97-04-08

Model 235 - 240/245 - 250 - 265

Trimmer guard

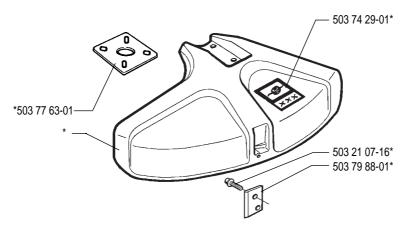
A larger, improved trimmer guard has been developed for the larger brush cutters. The guard fits mitre gear units with the mounting bracket parallel to the ground. The distance between the output shaft of the mitre gear unit and the edge of the trimmer guard is larger than on the earlier guard. The new guard accepts a line diameter of 500 mm compared to the previous 420 mm.

New ref.no. Description
503 91 60-01 Trimmer guard assy.
